Access Compliance Report

Public Rights-of-Way

(Curb Ramps)

Intersection ID: 42501	Main Street: BULLOCK_GREENWAY_BV	Cross Street: JAMES_BLAKENEY_AV	Location: SE
ADA ID: 2AF3F46B39E5	Ramp Type: PerpDiag	Initial Pass/Fail: Fail	Overall Compliance: No
			Severity Score: 36.25

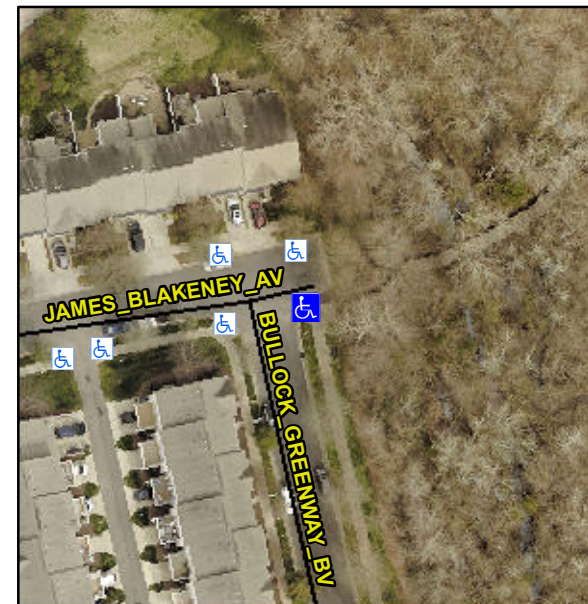
R304.5.1, R304.5.3

Remove & Replace Curb Ramp With Two New Directional Ramps or Equivalent.
